Harbour Energy Proposed Protective Provisions

Shown as mark-up to the Harbour Energy Without Prejudice Protective Provisions as Submitted by the Applicant at DL5

Protective Provisions Plan Spirit and Harbour

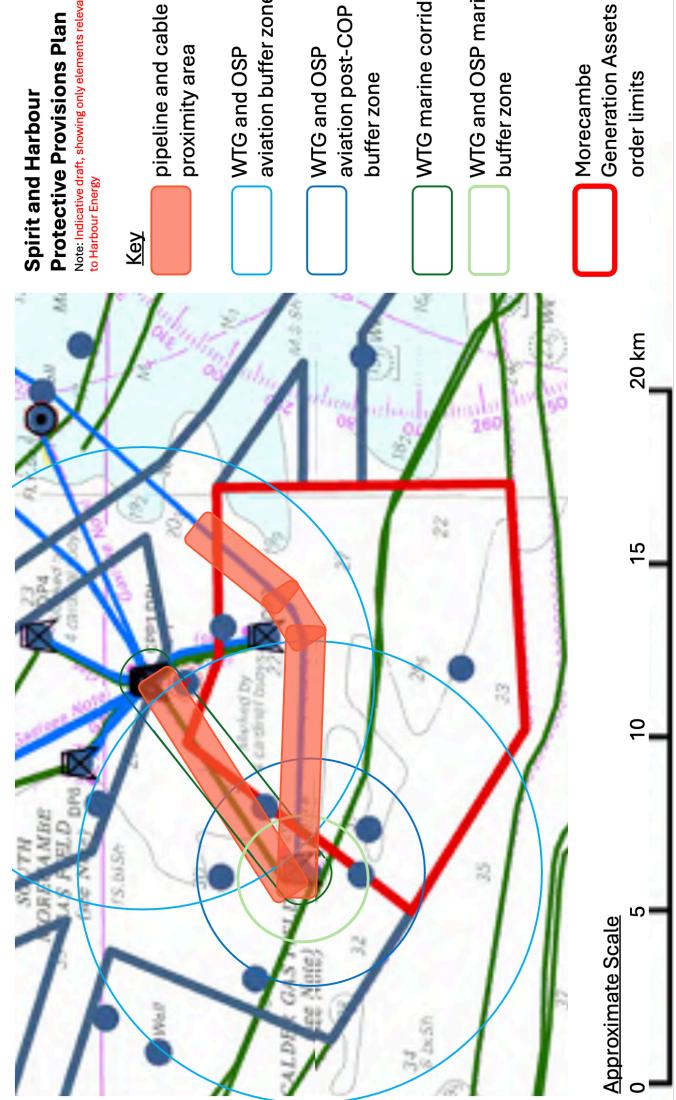
"WTG and OSP aviation post-COP buffer zone" means and circular area of one point fivenine nautical miles (1.51.9 nm) of clear airspace measured from the nearest outer extremity edge of the Calder Platform to any tip from any wind turbine generator located within the licence order limits and extending vertically from mean sea level, shown edged blue and annotated and shown as the WTG and OSP aviation post-COP buffer zone on the Spirit and Harbour Protective Provisions Plan:

"WTG and OSP marine buffer zone" means an area of one(i) a circular area of three point seven six nautical milemiles (43.76 nm) of clear airspace measured from the nearest outer extremity edge of the Calder Platform to any tip from any wind turbine generator located within the licence order limits and extending vertically from mean sea level; and

<u>each as shown</u> edged <u>in-light greenblue</u> and annotated and <u>shown</u> as the WTG and OSP <u>marineaviation</u> buffer zone on the Spirit and Harbour Protective Provisions Plan; <u>and-</u>

"WTG aviation corridorand OSP marine buffer zone" means a two an area of one nautical mile (21 mm) wide corridor of clear airspace angled at 220 degrees from CPP1 measured from the outer extremity edge of the Calder Platform and extending vertically from mean sea level shown edged in orangelight green and annotated and shown as the WTG aviation corridorand OSP marine buffer zone on the Spirit and Harbour Protective Provisions Plan; and

"WTG marine corridor" means a one nautical mile (1 nm) wide corridor of clear sea space between the Calder Platform and CPP1 edged in dark green and annotated and shown as the WTG marine corridor on the Spirit and Harbour Protective Provisions Plan.

Commented [HE7]: In the interests of co-existence, and as a development from earlier submissions, Harbour Energy is willing to accept that, with suitable compensation provisions, post-COP decommissioning work could be undertaken with rotor tips no nearer than 1.9nm. As clearly set out in Harbour Energy's Written Representation (REP1-102), the AW169 aircraft used in the East Irish Sea require an obstacle-free distance of 1.9nm upwind of a helideck in order to exec.....
